**SUBMISSION RE:
Manitoba Environment Act Proposal
Public Registry 6119.00
Silica Sand Extraction Project
Sio Silica Corporation (formerly CanWhite Sands)**

**To: Clean Environment Commission
13 February 2023**

Submitted by E. Pip, B.Sc. (Hons.), Ph.D.

Figure 51. Sonogram vertical plot from SSCRIR2 (CEC-IR App A) for BRU 92-8.

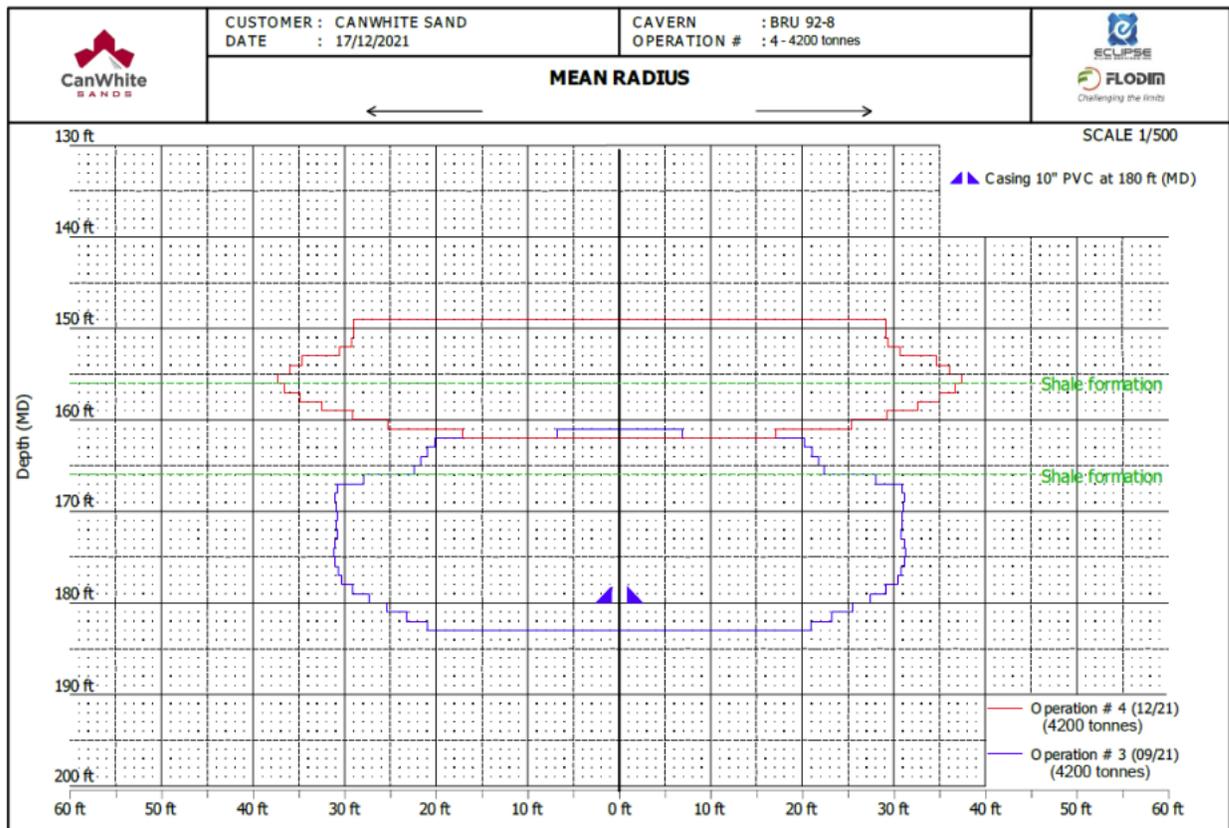
In SSCRIR2 (#CEC-IR-011), “It is **anticipated** that aquifer properties will remain very similar within undisturbed portions of the aquifer but will change locally within the water filled voids created following sand extraction. However, at the regional scale the water filled voids created following sand extraction will be separated by intact aquifer materials that will be **largely** unaltered. Overall, the aquifer is anticipated to maintain its current characteristics, but **will locally have more variable properties** in proximity to sand extraction wells.” (Emphases are mine).

Figure 115 A and B. Two images reproduced from Figure 1-1 of SUPPL1. Note: arrangement reverts to 7 wells per cluster again in RMSF-IR-004 and -006, then to <6 in NREP.

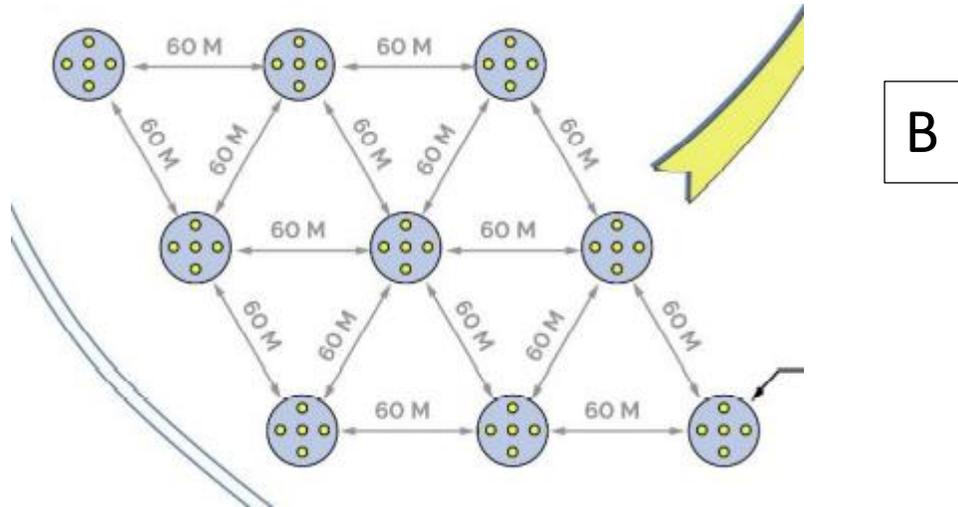
But then, in SUPPL1, Figure 1-1 (also GTTR, p. 5), there are now FIVE wells per cluster. If THIS version is the correct one, will a maximum of seven wells still operate at the same time, as this latter number has not been amended? But with 10 extraction rigs, this would mean that all wells in two 5-well clusters could/might operate simultaneously. The reader starts to get dizzy.

Date	Source	Page	Number of wells per cluster
Original proposal	EAP1	Figure 2-3	7
“	AppH(AppA6)	entire	7
June, 2022	SUPPL1	2 (Figure 1-1)	5
September, 2022	GTTR	5	5
November, 2022	RMSF-IR	-004 and -006	7
November, 2022	SSCRIR1 #MSSAC-IR RMSF-IR	009 006	secret
January, 2023	NREP	1/8	Any number <6

Figure 116. Revised proposed well cluster block arrangement (January 24, 2023)(NREP). Note that site sizes are represented as disproportionately small relative to remaining forest and unoccupied area. No trails are indicated.

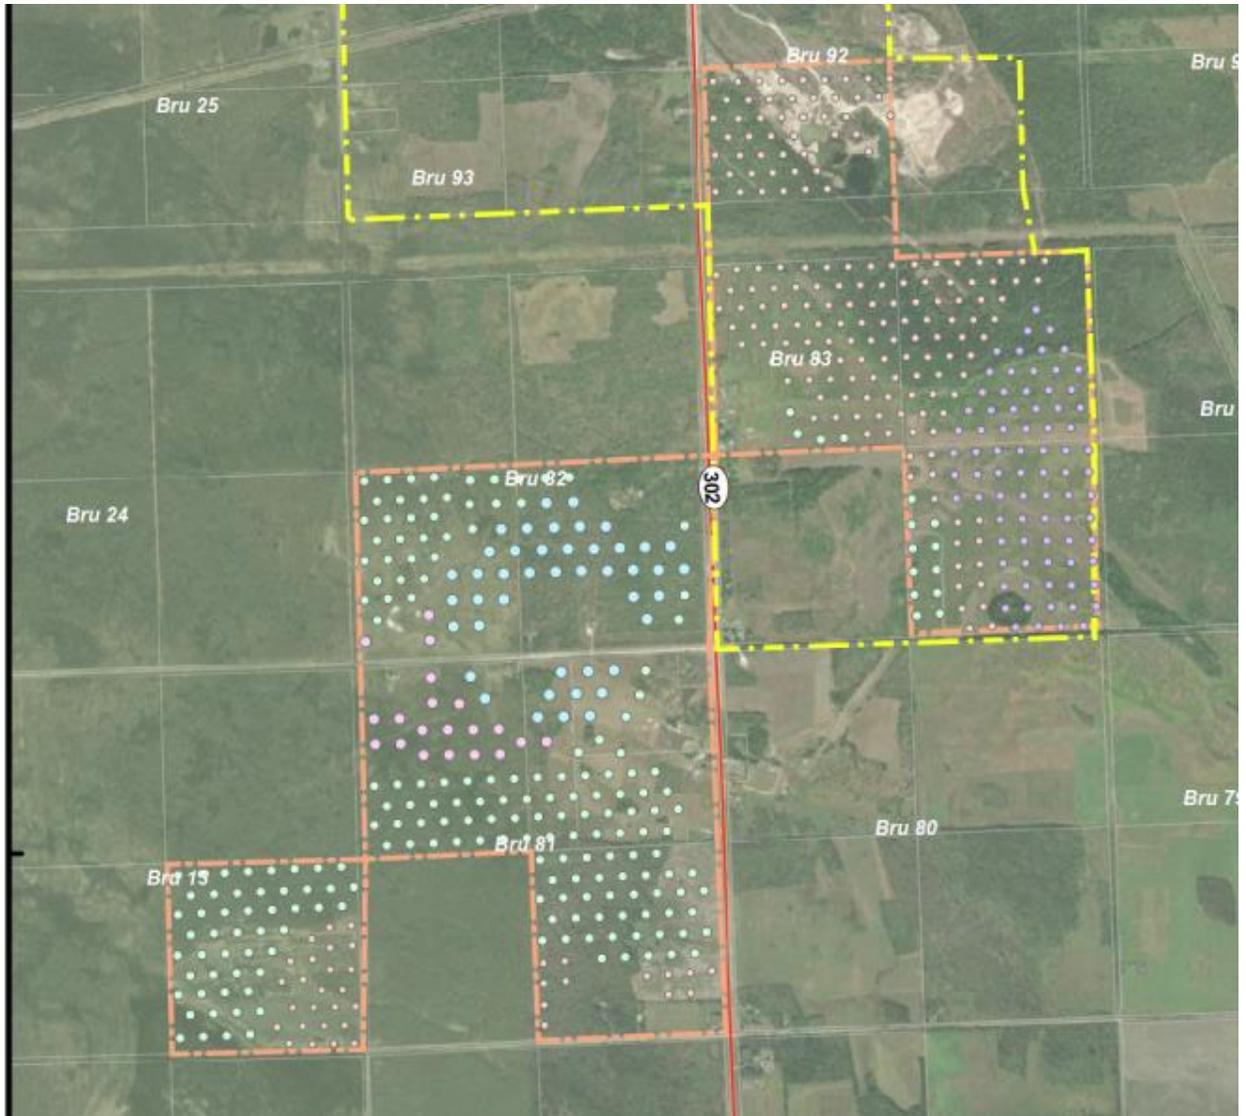
The EAP1 (p. 3) states: “although up to seven extraction wells may be operating simultaneously in one well cluster at any given time, this maximum number of wells operating simultaneously maybe [sic] spread across two adjacent well clusters”. In keeping with the constantly changing proposal, the number of wells per cluster has been subsequently altered to five, with four on the circumference and one in the center (SUPPL1, pp. 1 + 5, Figure 1-1), i.e. arranged in a quincunx, then subsequently reverted back to seven (RMSF-IR-004, -006), and then any number <6 (NREP)).
